REGULATORY INFORMATION DISTRIBUTION SYSTEM (RIDS)
DISTRIBUTION FOR INCOMING MATERIAL TOPREP

SUBJECT:
FORWARDING RESPONSES TO LTR "MARK II STP INFO REQUEST" WITH ATT, REQUEST FOR ADDL INFO" - MARK II CONTAINMENT POOL DYNAMIC LOADS", DTD 04/18/78.

SUBJECT: RESPONSES TO NRC REQUEST FOR ADDITIONAL INFORMATION (ROUND 3 QUESTIONS)

Reference: Letter "Mark II STP Information Request" with attachment, "Request for Additional Information" - Mark II Containment Pool Dynamic Loads" to I. Peltier (NRC -DPM) from C. Anderson (NRC - DSS), dated April 18, 1978

Figure 1

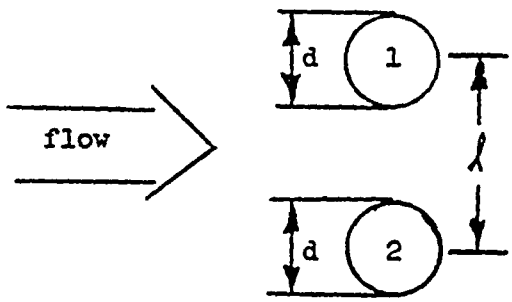
The DFFR (NEDO-21061) methodology for estimating steady state drag loads on submerged structures is unacceptable for those cases where the structures represent significant blockage to the pool water slug motion. We require that the drag coefficients used to compute the loads be modified according to traditional literature references which take account of the effect of blockage.

Structures such as the bracing that support downcomer vents experience drag loads as a result of the pool water slug motion. The distance between bracing pipes ranges from virtually touching to far apart. The bracing lies in a plane perpendicular to the pool slug motion, i.e., an orientation known in the literature as a side-by-side configuration. The drag coefficients, C_d, for this condition can be analyzed by considering the idealized case of two cylinders located side by side (see Figure 1).

For values of ℓ > approximately 3d, the literature shows no interference effects, and the drag is accurately predicted by considering the cylinders independently of each other. For values of ℓ less than approximately 3d, the effects of the sheer layer interaction between the lower boundary layer of #1 with the upper boundary layer of #2 results in a lowering of the values of C_D (see Figure 1). When ℓ = d (or when the cylinders touch), the C_D can be estimated as that of a flat plate of length 2d.

(i) Case 1 (Figure 1):

- For $\ell \geqslant 3d$, use steady-state C_D as before.
- For $1.1d \leqslant \ell < 3d$, use steady-state C_D as before.
- For $\ell < 1.1d$, use steady-state C_D for a flat plate of width 2d normal to flow

FIG. 1

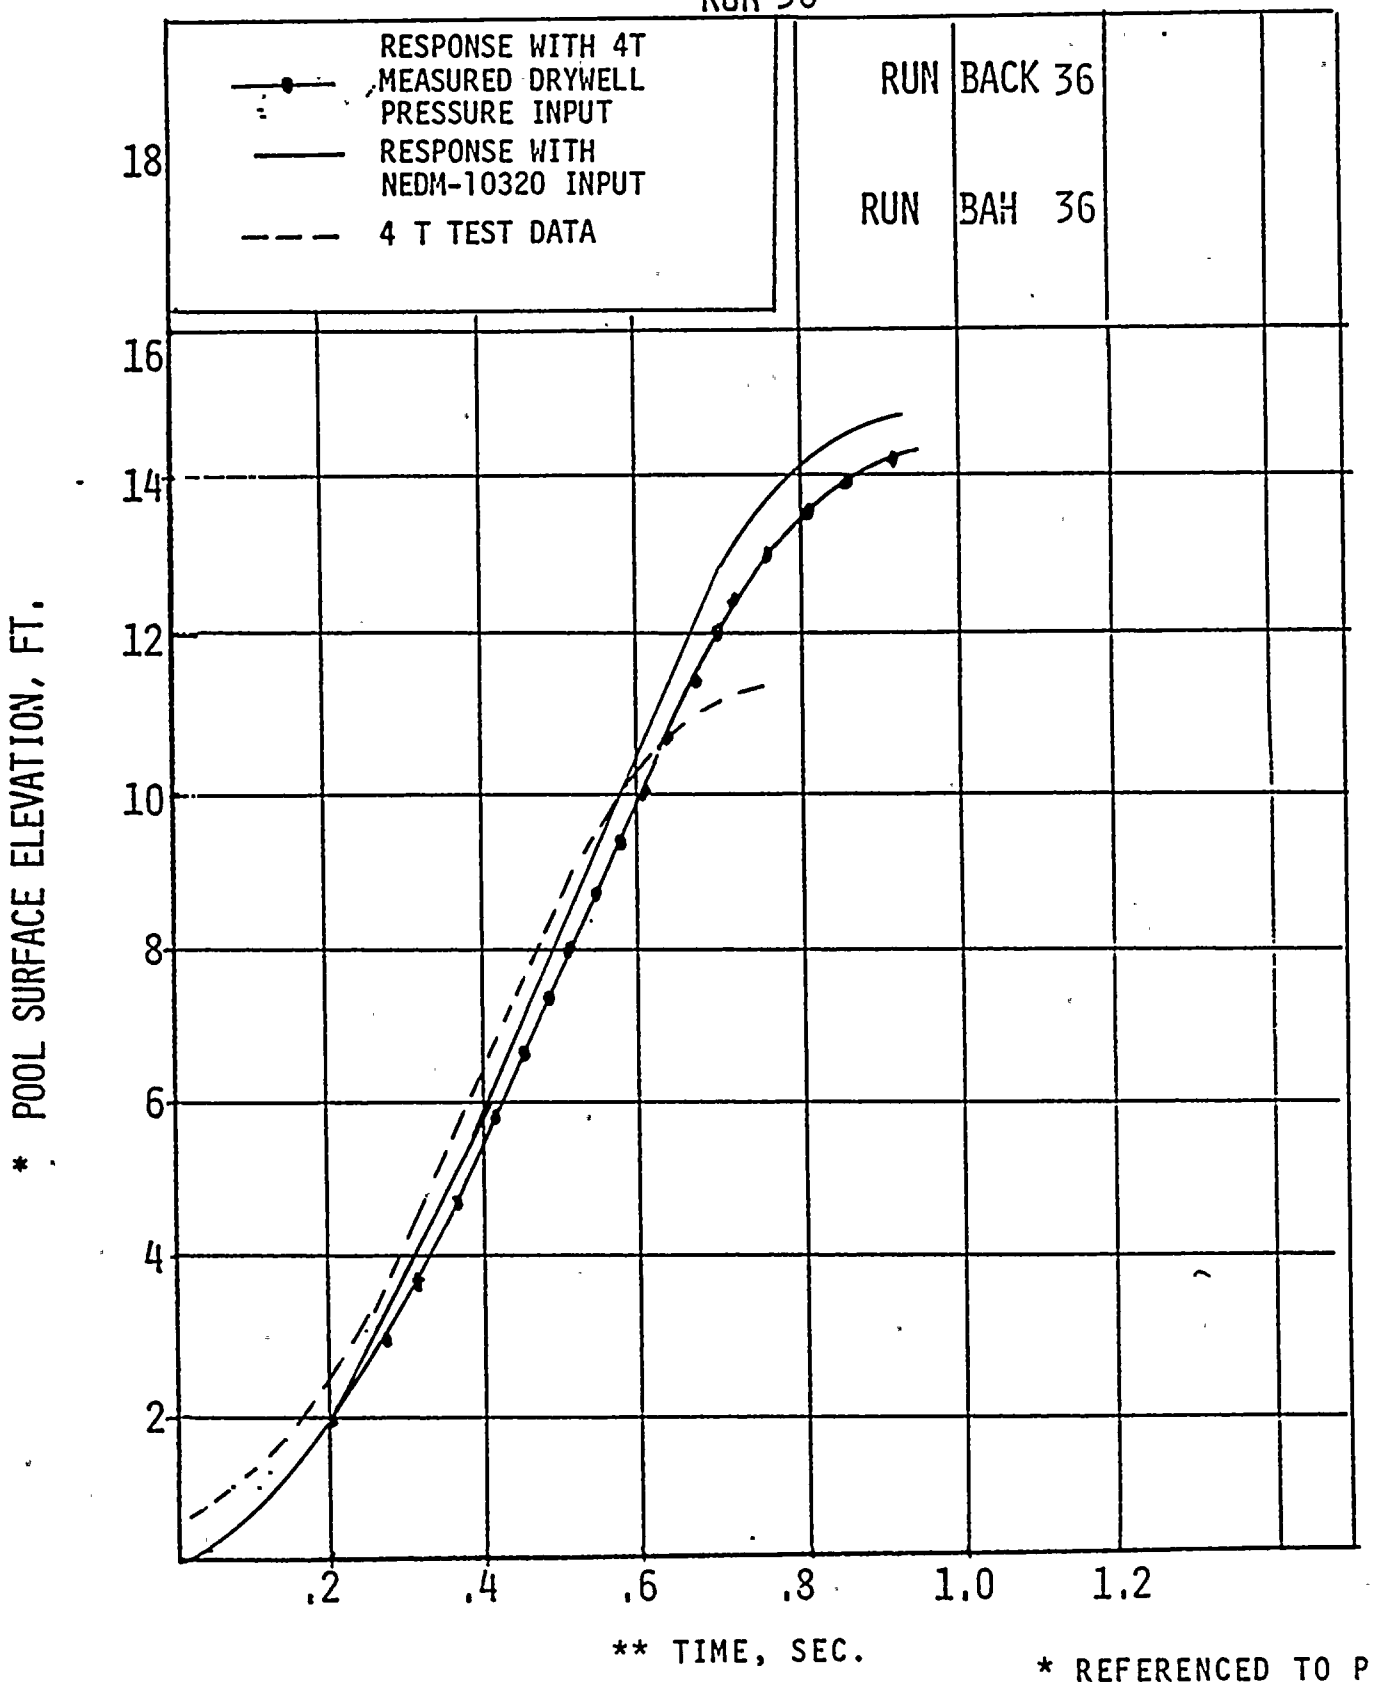
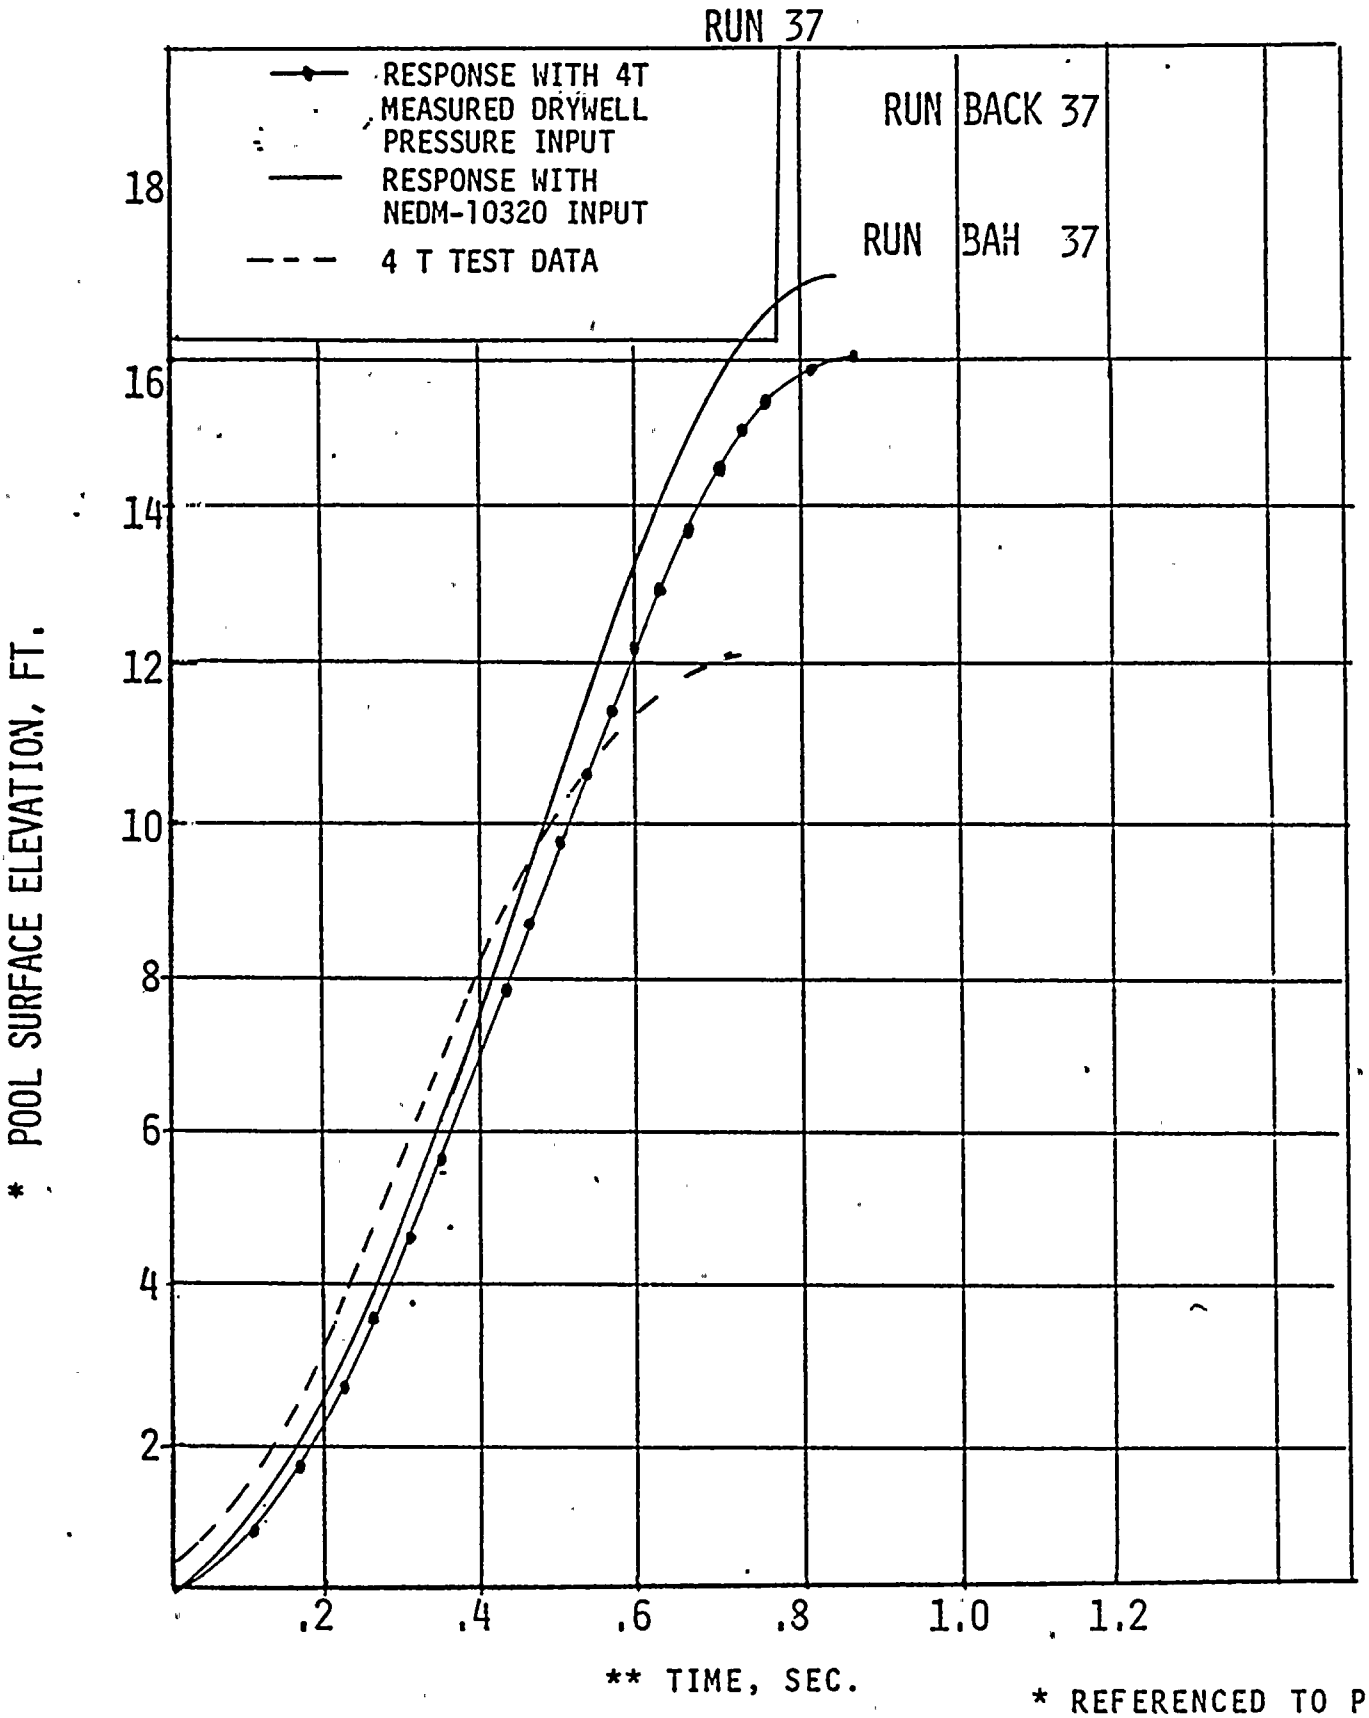
In the response to NRC questions M020.58(4) (NRC questions dated January 14, 1977) it is stated that "Calculations of pool swell for Mark II containments using the analytical model utilize the appropriate calculated drywell pressure response (NEDM-10320) as an input." It is our position that the specification of pressure history is an essential element of the DFFR methodology and that the particular choice cited above has not been demonstrated to be appropriate.

To justify such use, we require that pool swell calculations be made for selected 4T tests using drywell pressure response computed according to NEDM-10320 in lieu of the measured drywell pressure histories. The selected 4T tests are the two saturated liquid blowdowns made during the phase II test series (Runs 36 and 37). The response (pool swell elevation, velocity, bubble pressure) calculated in this manner should be compared with measured values and with similar calculations made using the measured drywell pressure histories.

For Mark II plant design assessment, the calculated drywell pressure response (NEDM-10320) has been conservatively chosen as input to the Mark II pool swell model. To illustrate this conservatism, the pool swell model calculations were performed for 4T test runs 36 and 37 using the computed drywell pressure response (according to NEDM-10320) as input. These calculations were compared to both the measured 4T pool swell response and the pool swell calculations using the measured 4T drywell pressure histories. The corresponding pool swell elevation, velocity, and bubble pressure are plotted in the attached figures.

The pool surface elevation curves (Figures 1 and 2) show that results using NEDM-10320 drywell pressures yield pool swell elevations which exceed the measured 4T test data, and also exceed the results obtained using the 4T-measured drywell pressure.
